AOMCC SQUARE FOUR CON-RODS - PART NO 1111-04

IMPORTANT - clearance between rods and liner spigots.

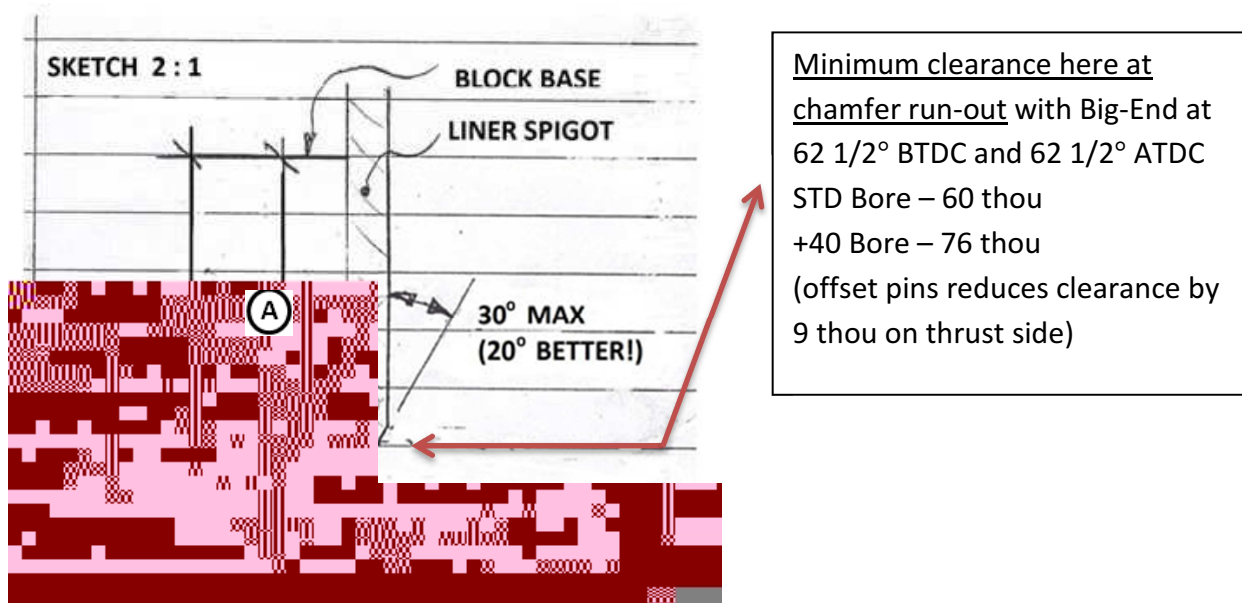
Problems with lack of clearance have been identified in engines that have blocks faced off and then counterbored to allow flange of liner to seat fully – this allows liner spigot to protrude too much into crankcase. Situation not improved if block base also faced off. Some pattern liners are too long and/or with incorrect lead-in chamfer.

* Use above sketch to check liner spigots!

- The most important dimension is the run-out of the chamfer at (A) below block base.

If liner spigot requires correction, this can be done without removal

- Adjust chamfer where rod comes close for 3/4" width and run-out at (A) from base.

OR

- Cut slots 3/4" wide with bottom (A) from base plus small chamfer.

DIMENSION A - STD 18mm, +20 18 1/2mm, +40 19mm
